# OREGON CITY

**FILE NO.:** HR 14-04

**REQUEST:** Modification to HR 13-04 (Mike's Drive-In) in the McLoughlin  
Conservation District (related file SP13-16)

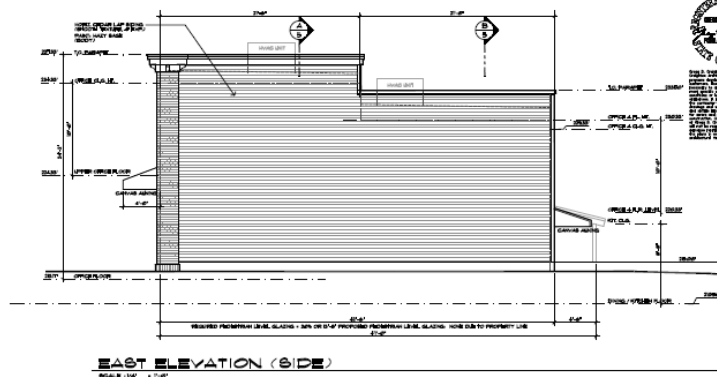
The covered arcade/ porch is proposed to warp around the Monroe street elevation.

Building shifts south onto newly acquired property. The future addition is not part of this request.

EAST ELEVATION (SIDE)

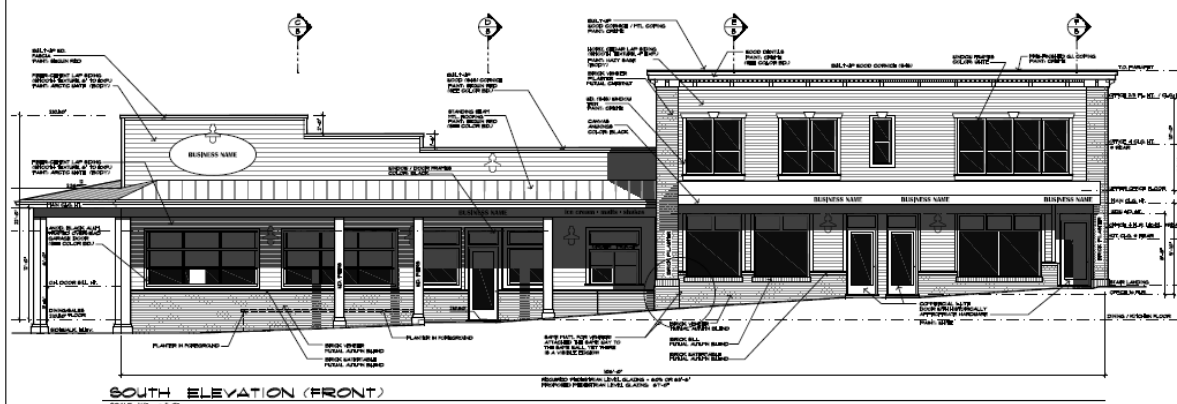
The depth of the covered porch area increased by 18 inches as did the office areas at the front of the eastern portion of the building. (offices 1a, 1b, 2 & 3) The previously submitted design featured an 8' deep covered area. The revised design (now submitted) shows the porch at 9'-6" deep measured from the front wall of the restaurant to the outside face of the columns.

Staff finds that the inclusion of a wrapped porch on the Monroe Street elevation is an appropriate approach to a corner storefront design.
